# Technical Service Bulletin

## 70 Noises from doors

70 15 43 2039023/2 January 30, 2015. Supersedes Technical Service Bulletin Group 70 number 14-41 dated November 18, 2014 for reasons listed below.

Model(s)	Year	VIN Range	Vehicle-Specific Equipment
Q5	2013 - 2014	All	Not Applicable
Q5	2015	000001 - 038877	Not Applicable

**Figure 4.** Rear door panel.

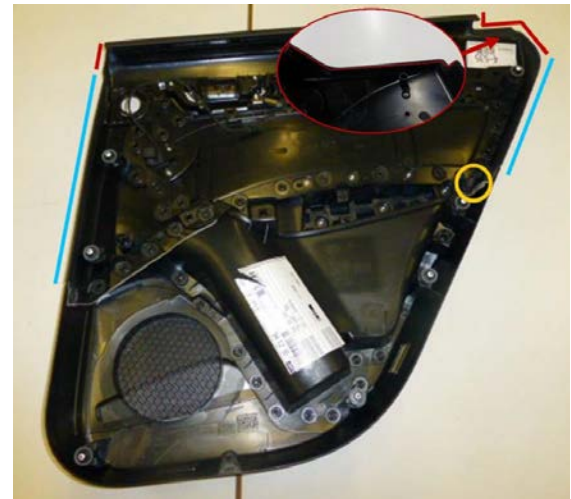
1. The illustration to the right (Figure 4) shows the rear door trim panel removed and the areas of the trim panel to be isolated.
  - The area of the door trim panel marked blue will be isolated using **000 979 950** webbing adhesive tape.
  - The upper areas indicated in red are to have **G 052 172 A1** special lubricant applied. Carefully apply the lubricant *only* to the edges that make contact with the door.
  - The support rib for the mounting clip (yellow) will have **533 867 910 A** Adhesive Felt Strip applied.
